Castor wheel bolt for Panthera X

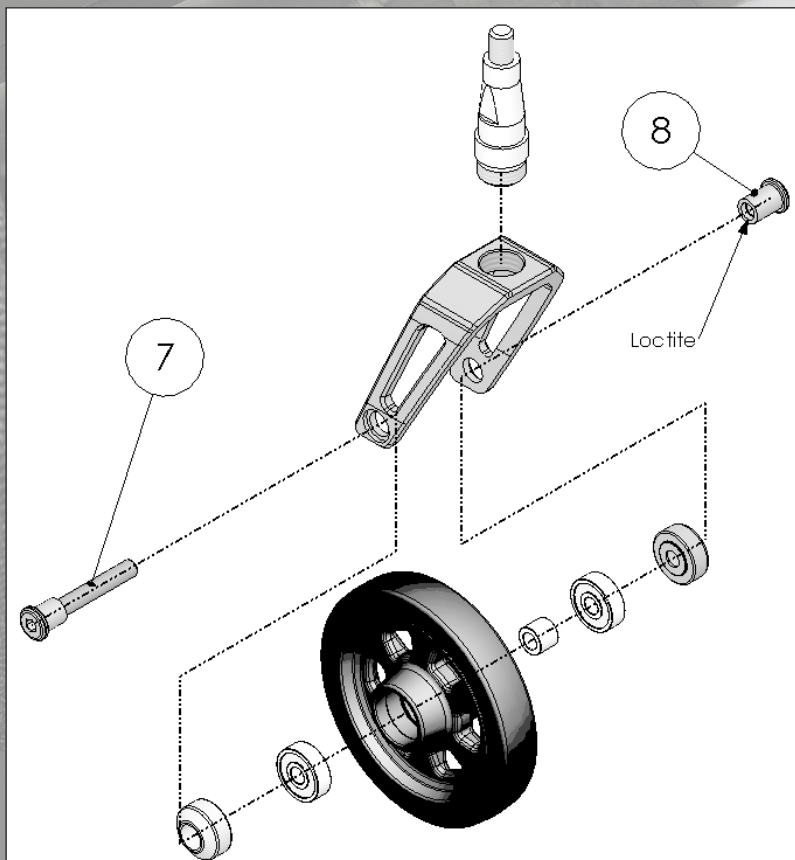
On the first 100 Panthera X delivered, an improper threadlocking (Loctite) has been used on the castor wheel bolt. (pos. 6 och 7)

It has been too strong which mean that the bolt could deform when disassembling the castor wheel, due to the force needed to loosen the bolt.

For those customers that has been affected by this. we offer a new bolt and nut for free. Contact Panthera and we post it without delay.
